| | UNITED STATES | NTERIOR | RECE | IVE | OMB N | APPROVED O. 1004-0135 July 31, 2010 | |
|--|---|---|---|--|---|---|--|
| BUREAU OF LAND MANAGEMENT OCD Artesia SUNDRY NOTICES AND REPORTS ON WELLS MAY 2 1 2013 Do not use this form for proposals to drill or to re-enter an abandoned well. Use form 3160-3 (APD) for such proposals. | | | | | 5 Lease Serial No. NMLC04581 578 8 6 If Indian, Allottee or Tribe Name | | |
| 1. Type of Well 🖸 Gas Well 🚺 Other | | | | | 8. Well Name and No. HASTIE AXH FEDERAL 1 | | |

Hastie AXH Federal 1 30-015-31622 Yates Petroleum Corporation May 17, 2013 Conditions of Approval

Wellbore schematics attached.

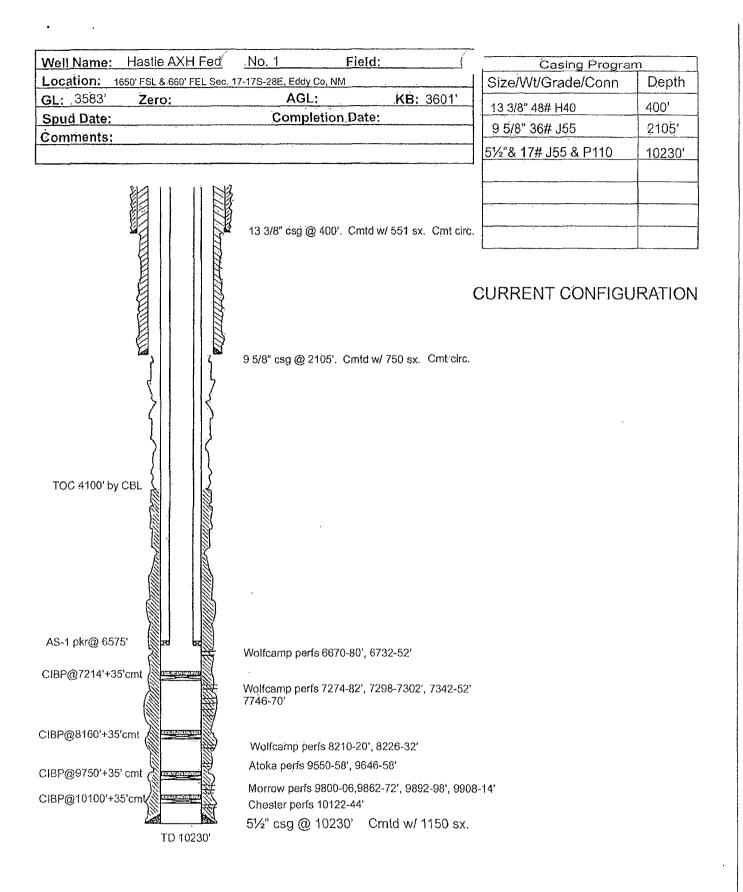
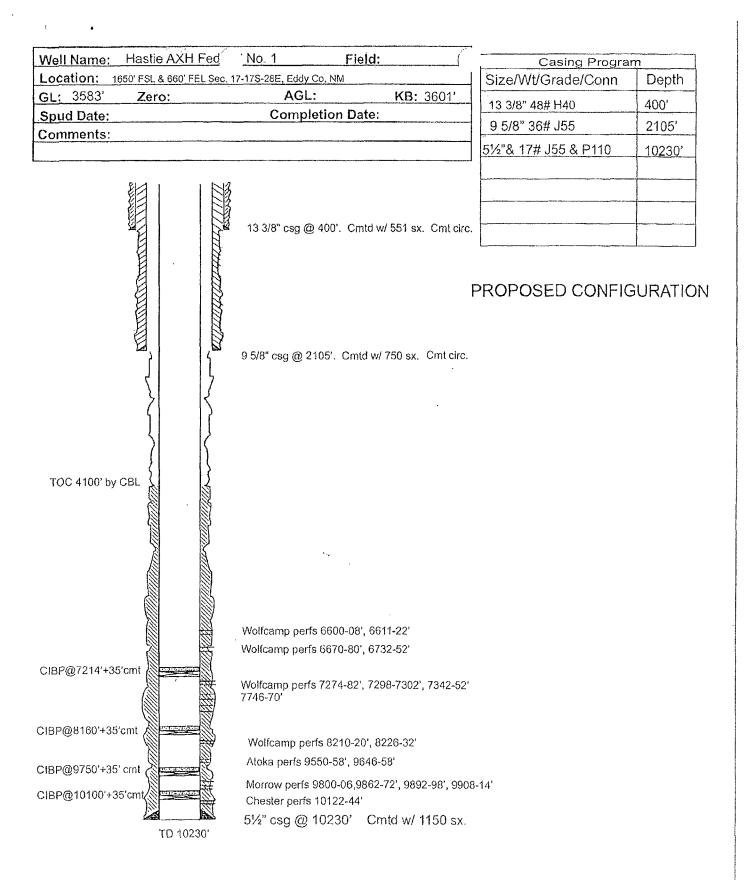
- **1.** Must conduct a casing integrity test before perforating and fracturing. Submit results to BLM.
- 2. A CIT is to be performed on the production casing per Onshore Oil and Gas Order 2.III.B.1.h.

10. Subsequent sundry required detailing work done and completion report for the new formation. Operator to include well bore schematic of current well condition when work is complete.
